Subject: *Response to Comments by the Union of Concerned Scientists Regarding the Request by Niagara Mohawk Power Corporation to Extend Core Shroud Inspection Interval for Nine Mile Point Unit 1*

ATTACHMENT 1
RESPONSE TO UNION OF CONCERNED SCIENTISTS QUESTION RELATIVE TO
NIAGARA MOHAWK POWER CORPORATION'S REQUEST TO EXTEND THE
NINE MILE POINT UNIT 1 CORE SHROUD INSPECTION INTERVAL

**Figure 3: Crack Depth vs. Time: NMP-1 Shroud Vertical Weld Cracks
(Parameters Selected for Consistency with Current Depth of Cracking)**

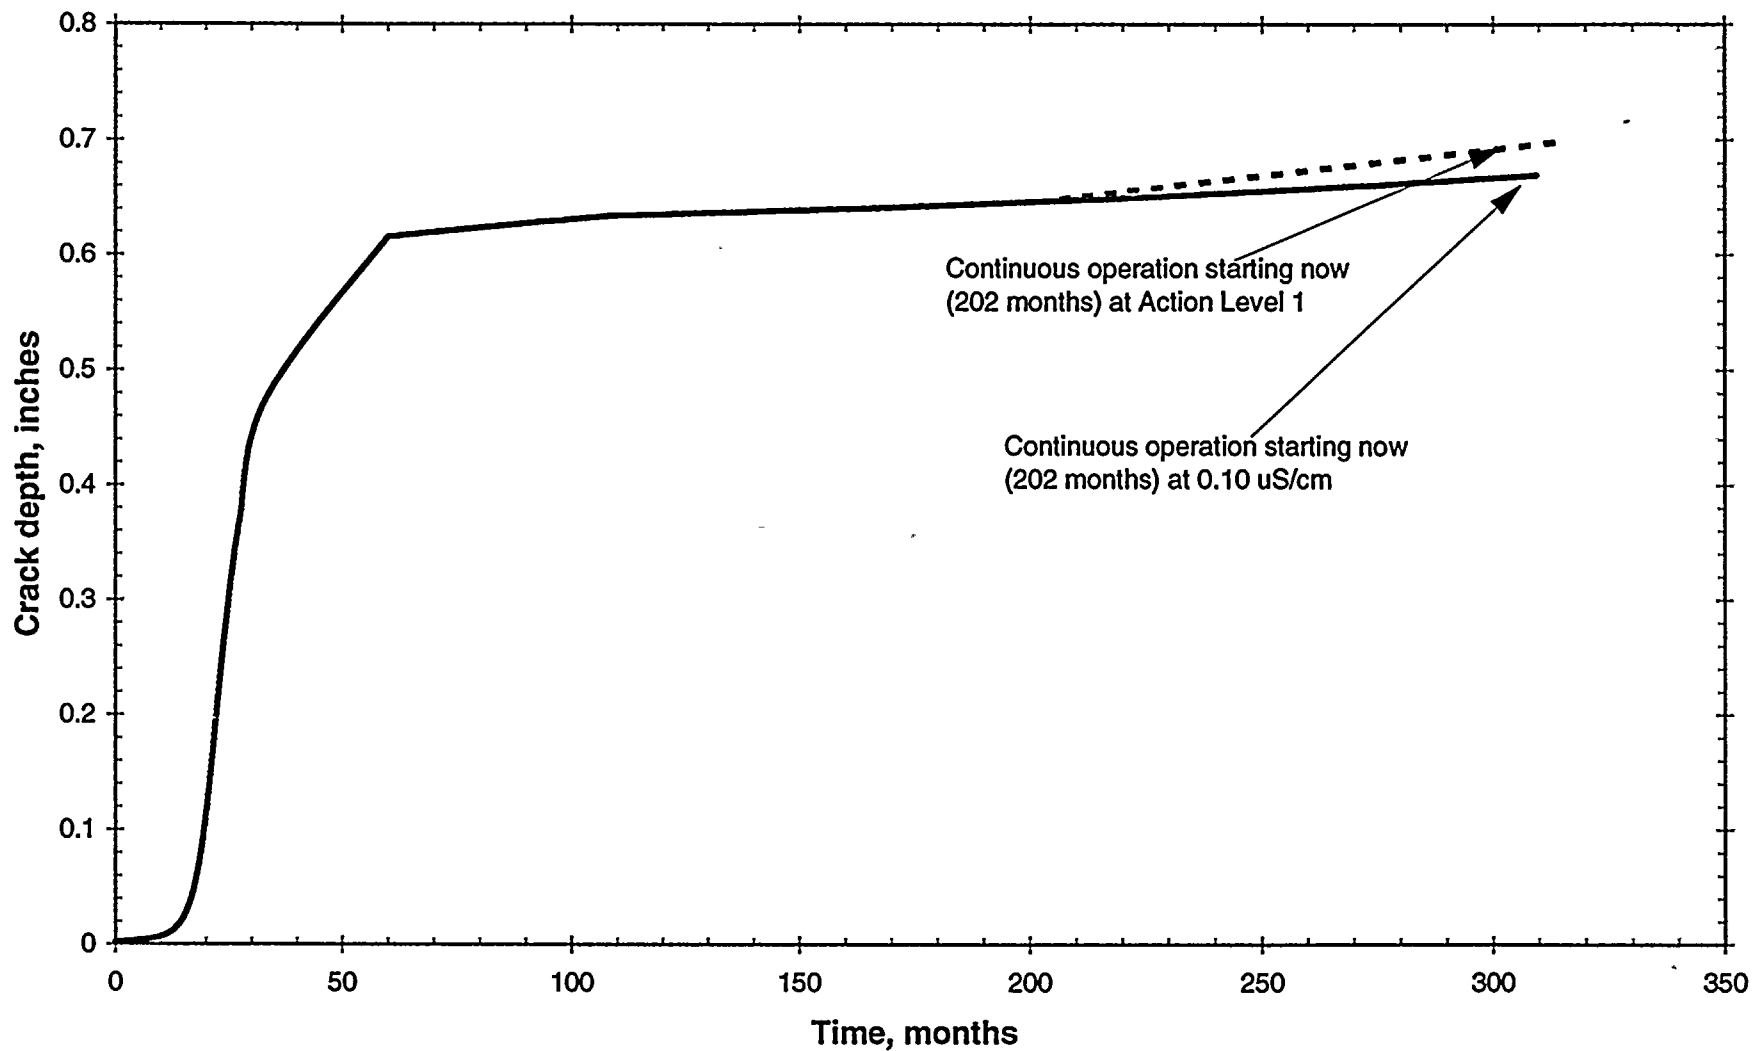
Can Figure 3 from General Electric report GE-NE-523-B13-01869-113NP be made publicly available.

A non-proprietary version of Figure 3 is provided as Attachment 2.
